N5241A-03A

**S E R V I C E N O T E**

Supersedes:  
N5241A-03

N5241A PNA Series Microwave Network Analyzers

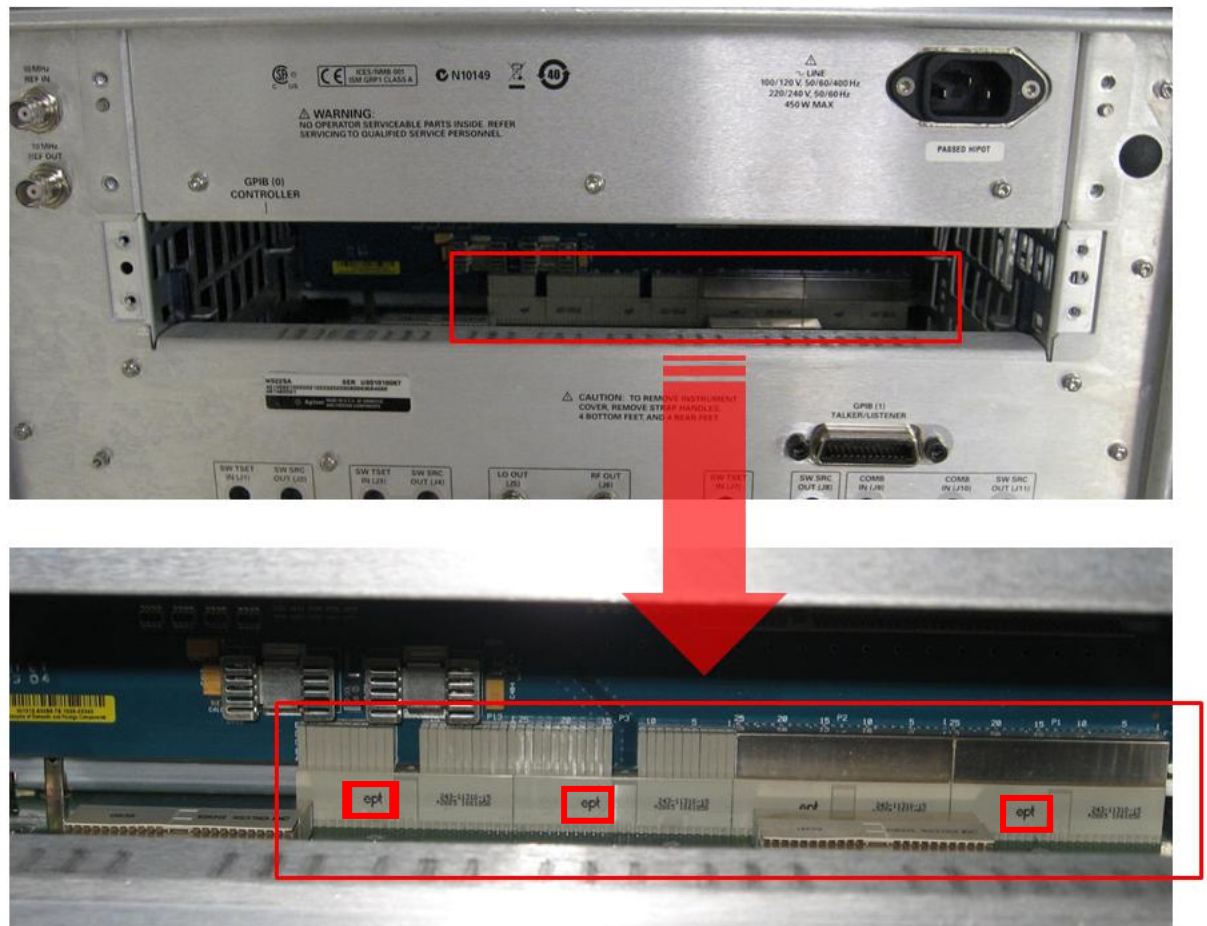
1. Remove the CPU assembly from the analyzer's rear panel. Refer to the PNA Service Guide chapter 7 section titled, "Removing and Replacing the CPU Board Assembly" for removal and reinstallation procedures. To view the online Service Guide, see the numbered list on the next page for instructions.
2. As per the photo below, inspect the system motherboard connector to see if it has one or more "ept" logos.

3. If the connector has one or more “ept” logos, return the analyzer to Agilent for replacement of the system motherboard. If the connector does not have one or more “ept” logos, email [ctd-soco\\_support@agilent.com](mailto:ctd-soco_support@agilent.com), providing the analyzer model and serial number and details of the malfunction symptoms.
